*BEACON PLANNING BOARD*  
*One Municipal Plaza - Courtroom*  
*BEACON, NEW YORK 12508*  
*Phone (845) 838-5002 Fax (845) 838-5026*

The Planning Board will meet on **Tuesday, May 9, 2017** in the Municipal Center Courtroom. A work session will take place at 7:00 PM for a training workshop, discussion of agenda items and/or topics of interest to the Planning Board. The regular meeting will begin immediately thereafter, but not later than 7:30 p.m.

**City of Beacon Planning Board**  
**5/9/2017**

**Site Lighting Plan**  
 Sheet 3a of 13  
**Edgewater**  
 Beacon, New York  
 Scale: 1" = 40'  
 January 31, 2017

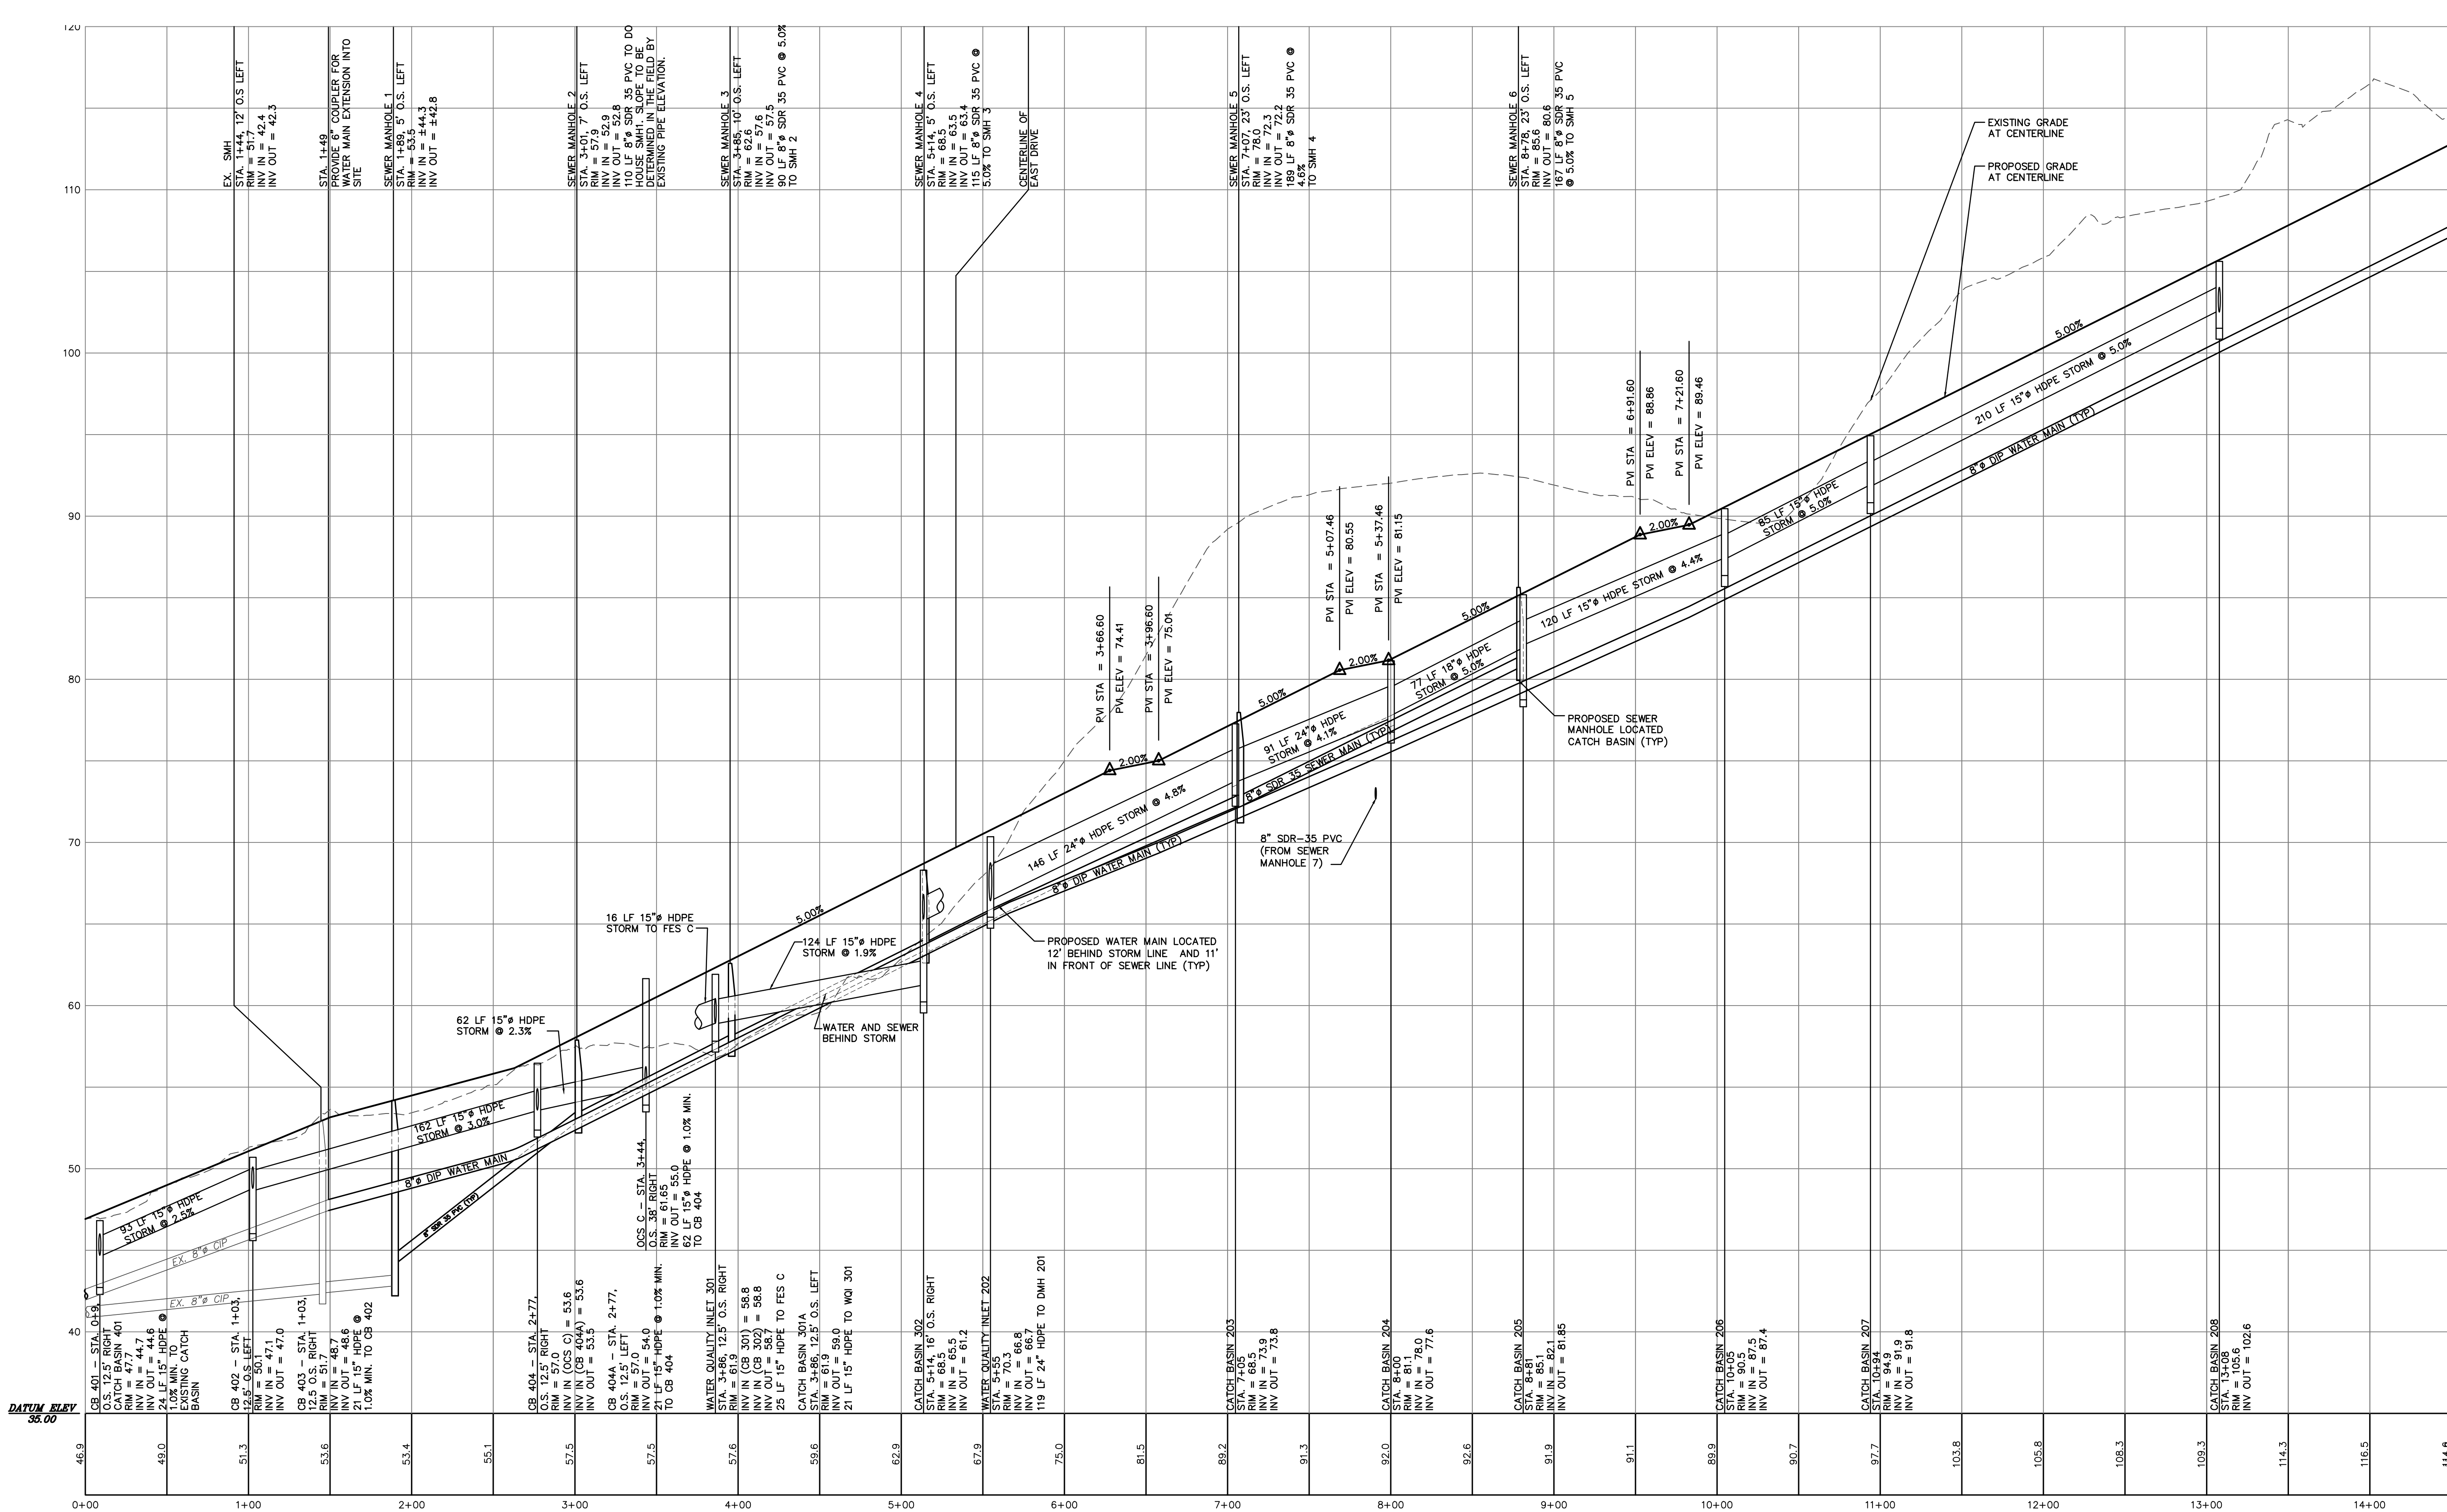
2. The Site Plan shows 67 landbanked parking spaces on the site (deducting at least two spaces for the entrance). The notes on Sheets 1 and 3 should be updated. The designated location for the extra spaces is on steeply sloping ground, which would require a very high, expensive retaining wall more than 500 feet long near the Bank Street frontage.

**West Drive Profile**

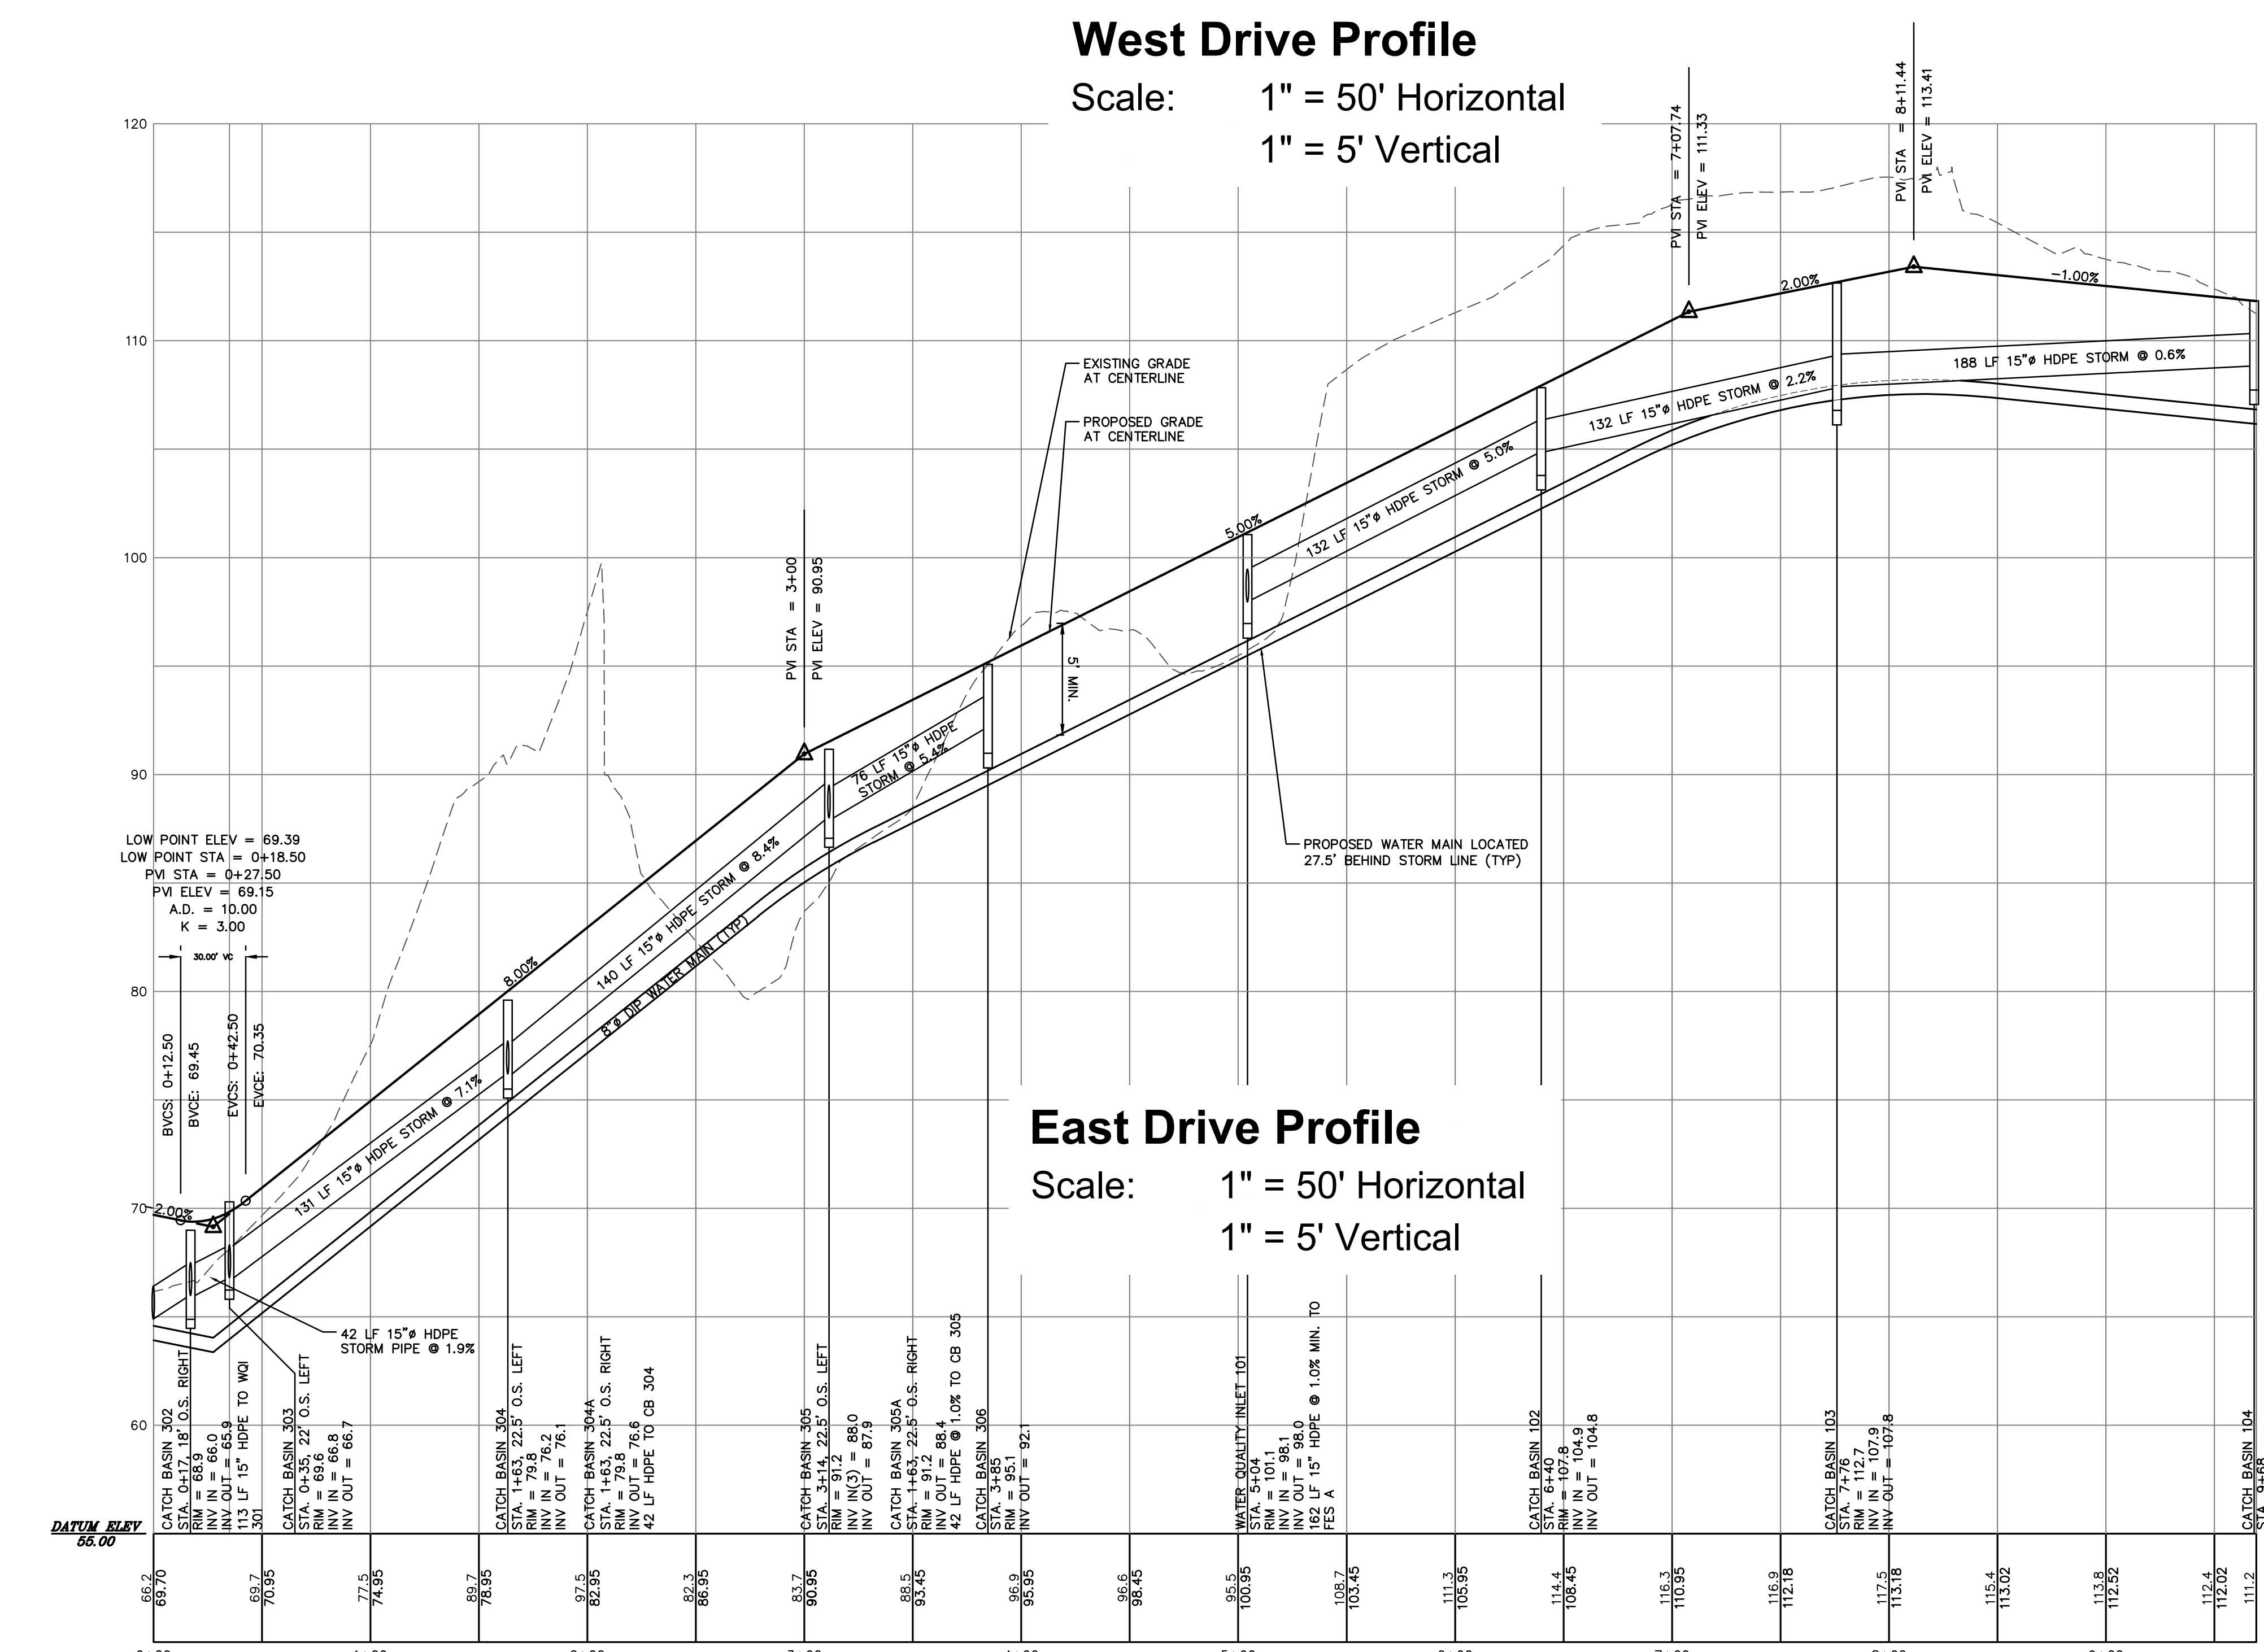
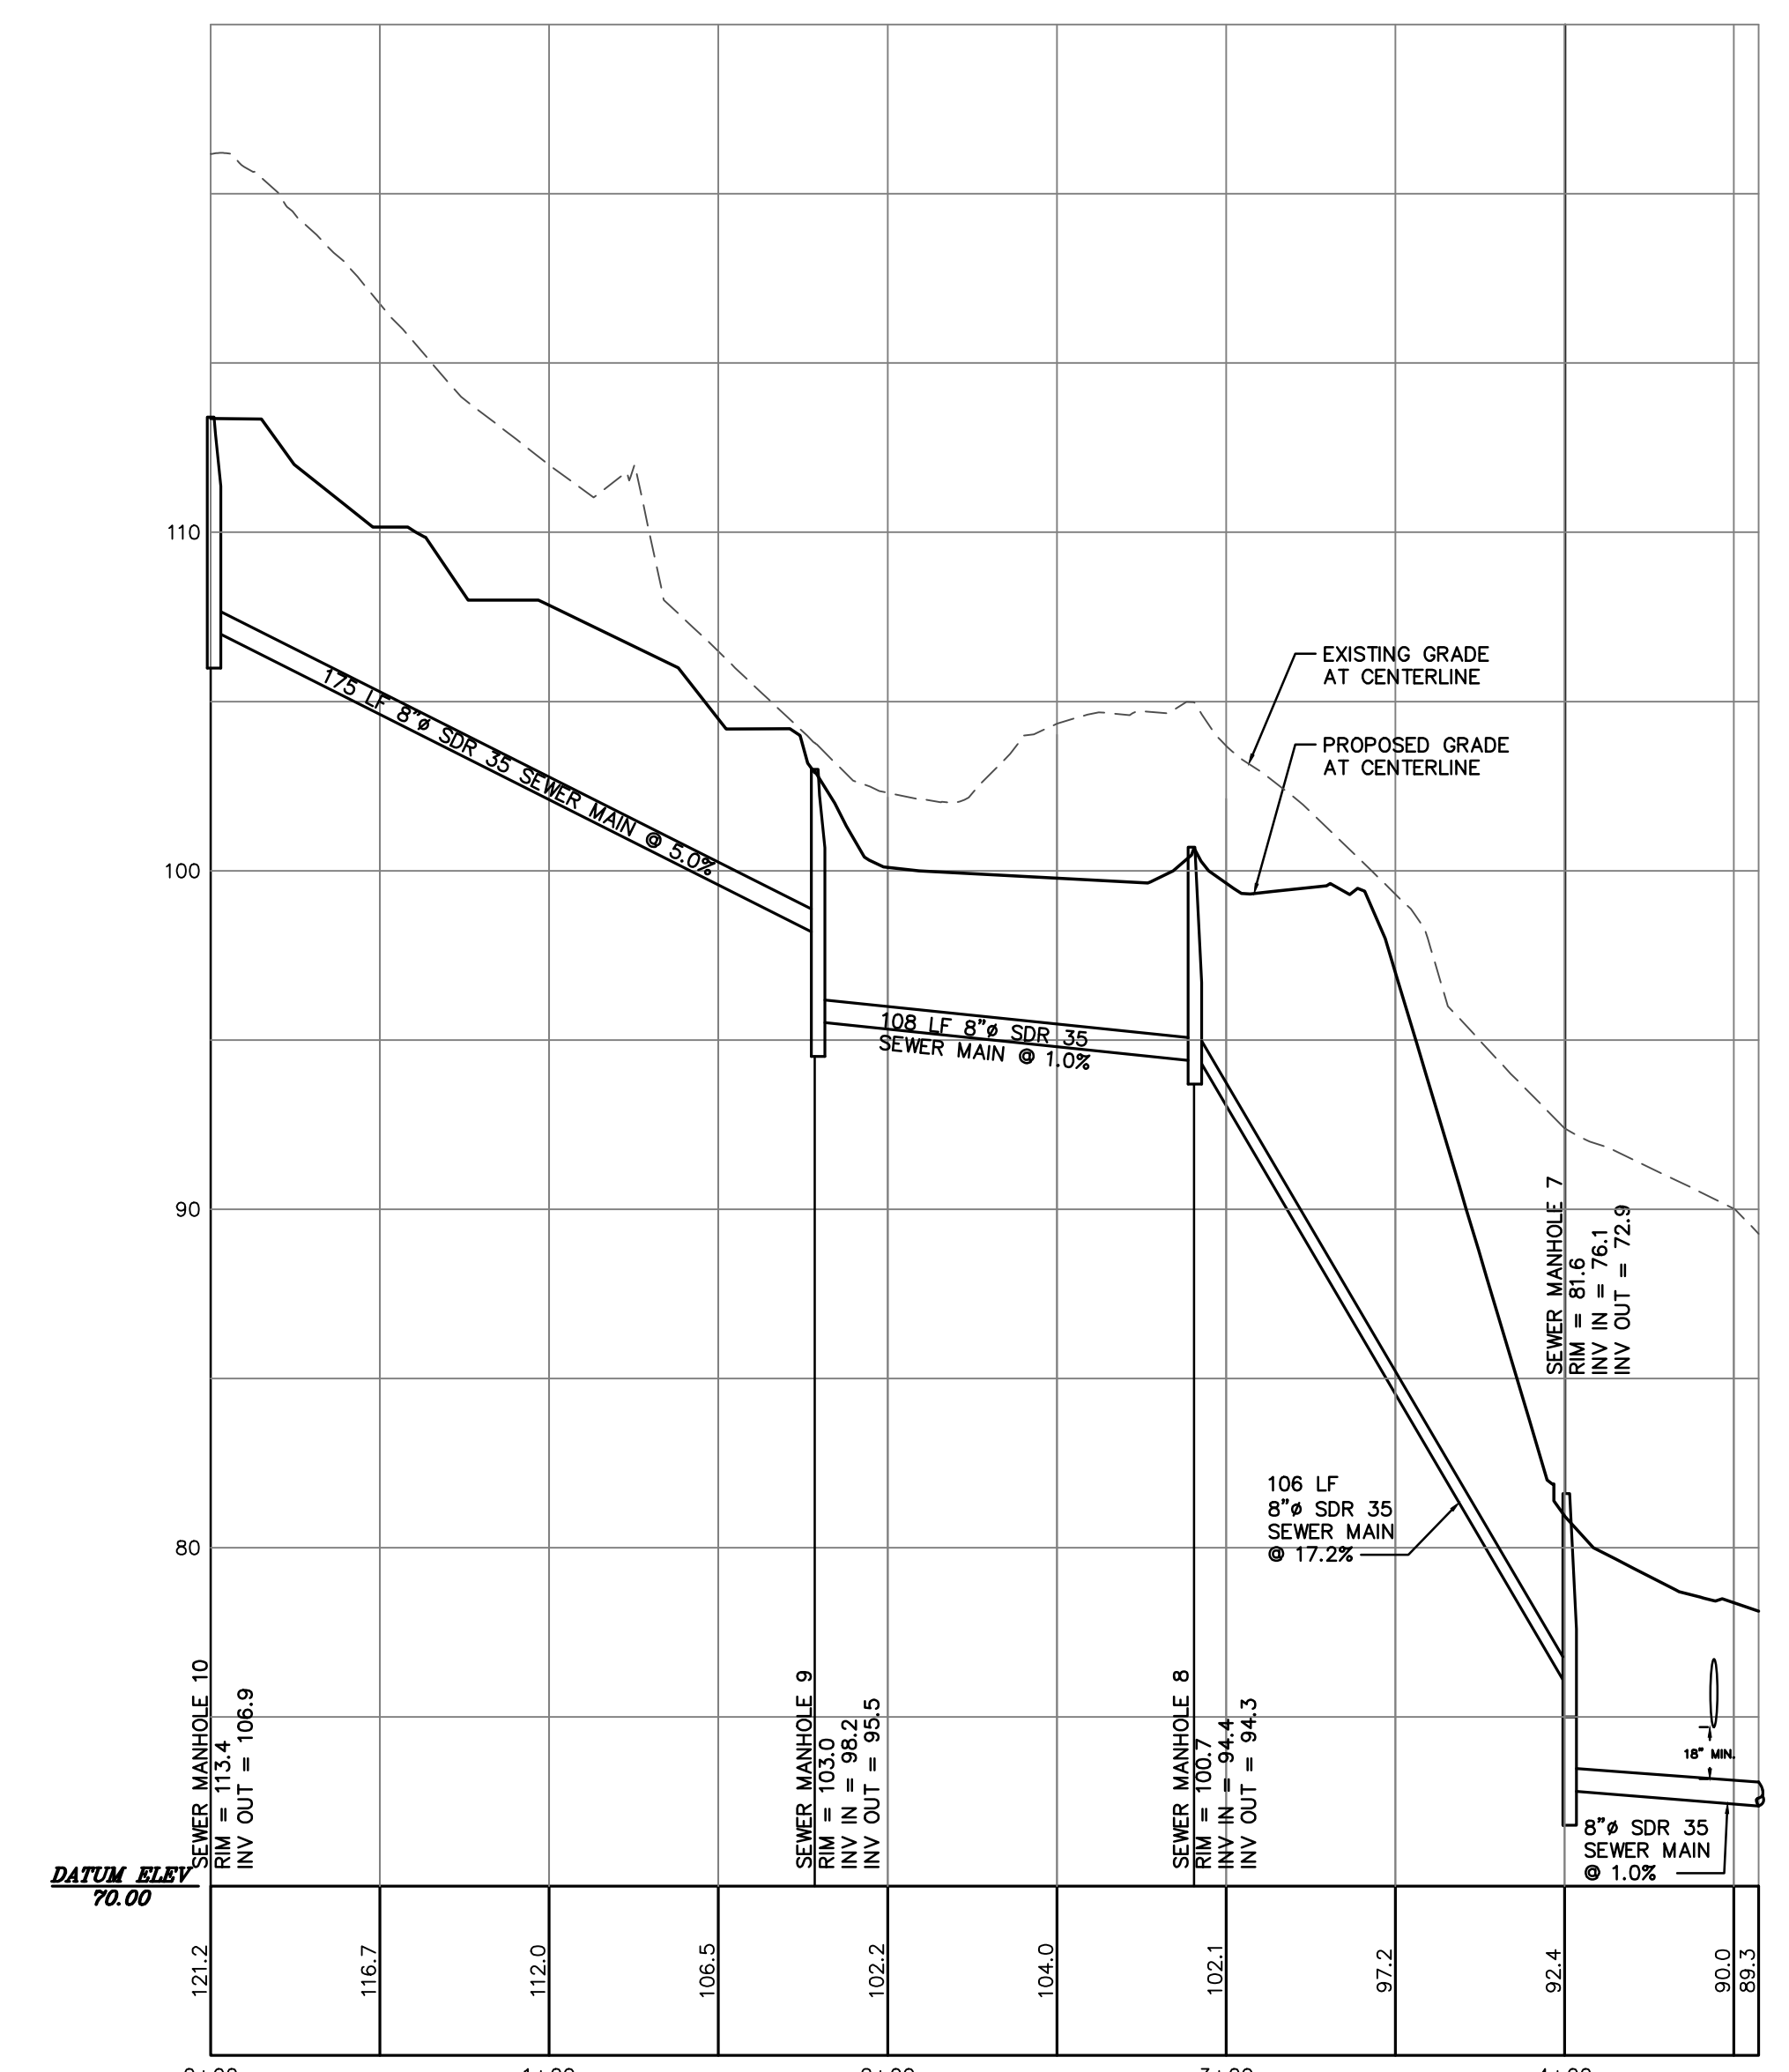
#### **Sheet 10 of 13 – Profiles**

1. Infiltration testing will be performed in the next few weeks, and the City Engineer will be contacted prior to the testing so that the tests can be witnessed.
  2. The WQ calculations will be updated with the value of 1.4 per figure 4.1 in the latest SWDM. It should be noted that the infiltration basins have been sized to infiltrate the 1-year storm, so the increase in WQ<sub>v</sub> will be met with no modifications to the infiltration basins. This information will be provided in a final SWPPP for review once the board has accepted a final layout.
